ON-SITE SEWAGE DISPOSAL SYSTEM HOWARD COUNTY HEALTH DEPARTMENT BUREAU OF ENVIRONMENTAL HEALTH

ADDRESS: 2211 Woodbine Road (Route 94) PROPERTY OWNER: _____

7/30/04 B00149390 2 STORY ADDITION w/ BASEMENT

LOCATION DRAWING

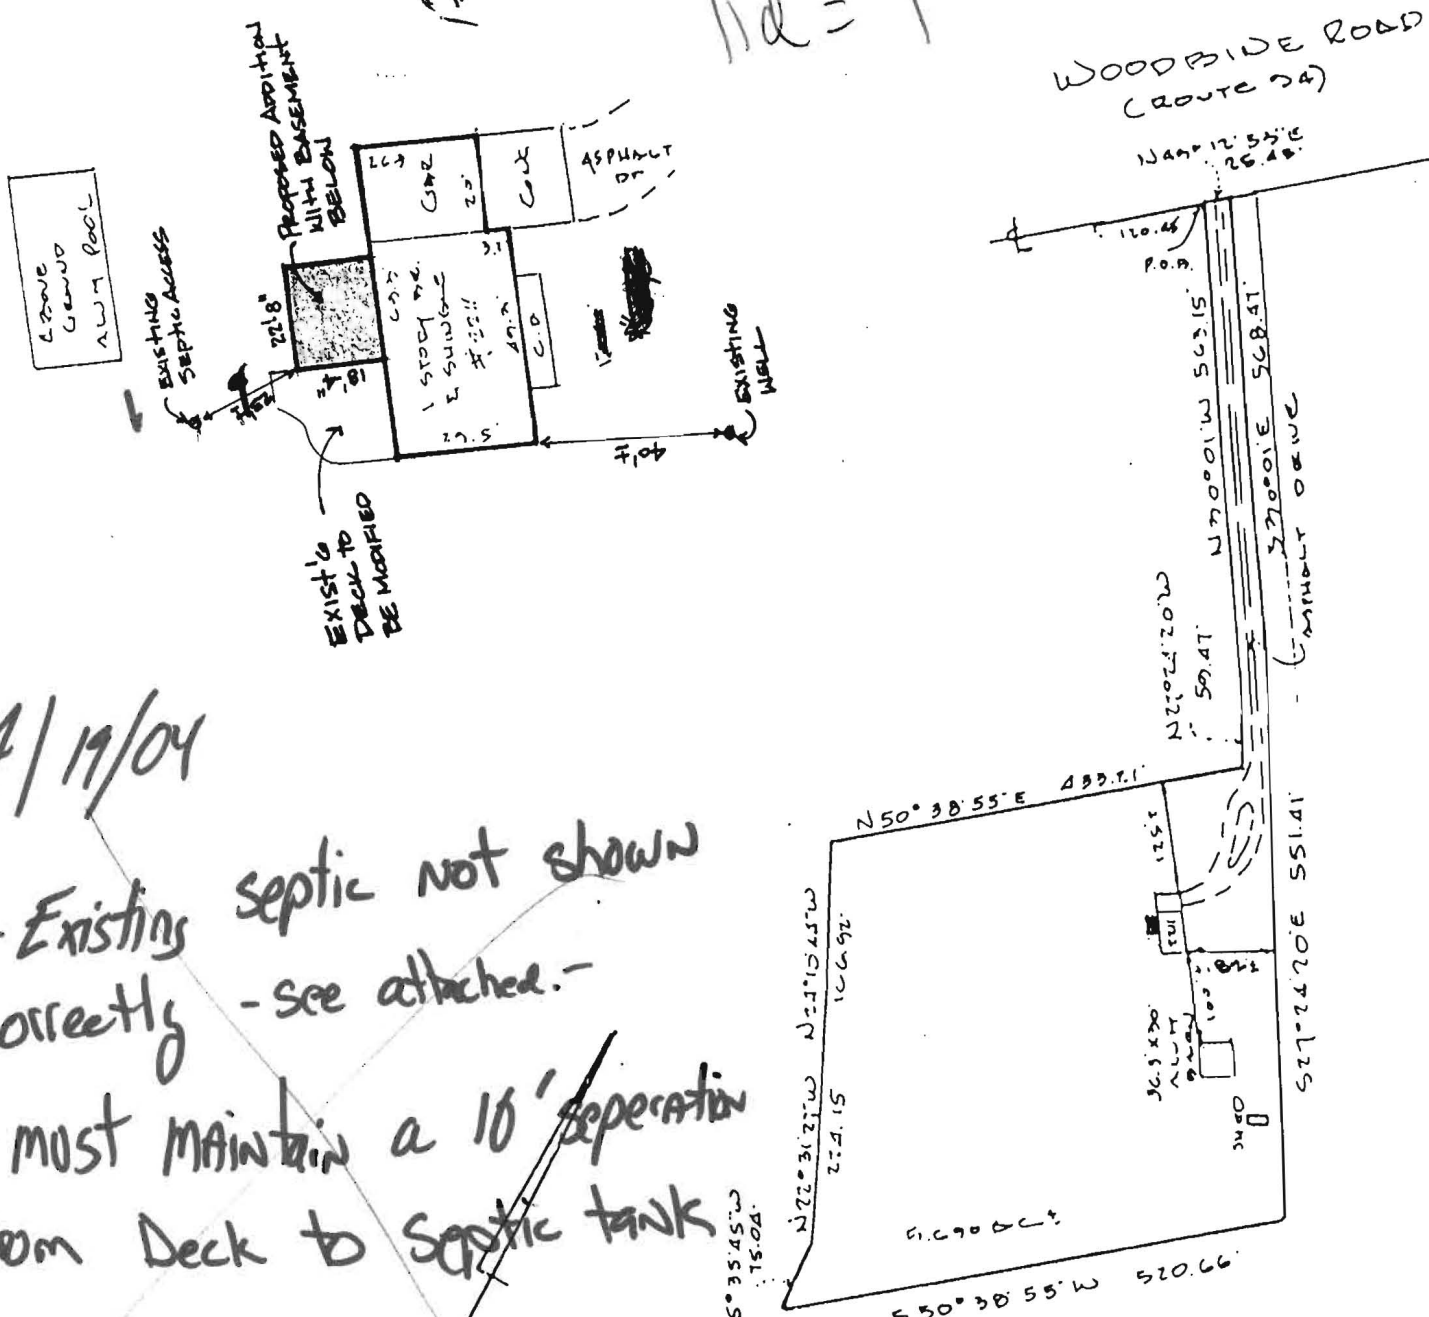
7/29/04 ON
 Site inspection

7/27/04
 Popped since
 last inspection

Depth to tank ~~4'~~
 lid = 1'

- Existing septic not shown
 correctly - see attached.

- must maintain a 10' separation
 from Deck to septic tank

7/30/04
 Proposal addition OK

LOCATION DIAGRAM

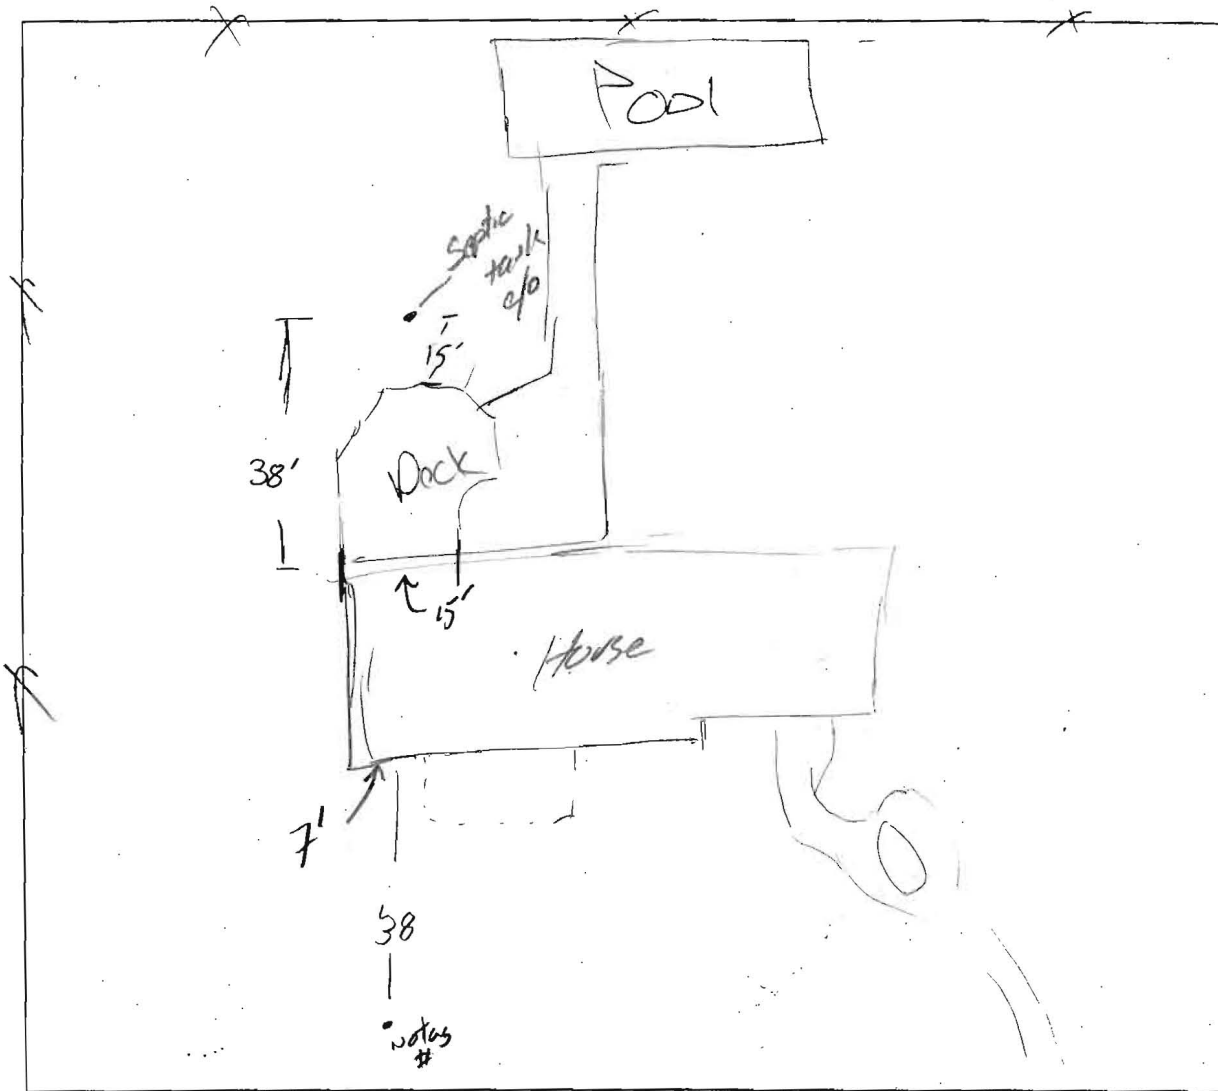
COMMENTS: Depth to sewage 2' in tank 7/21/04 Site re-visited
ON 7/27/04 - tank has been pumped. Depth to top of tank 1'
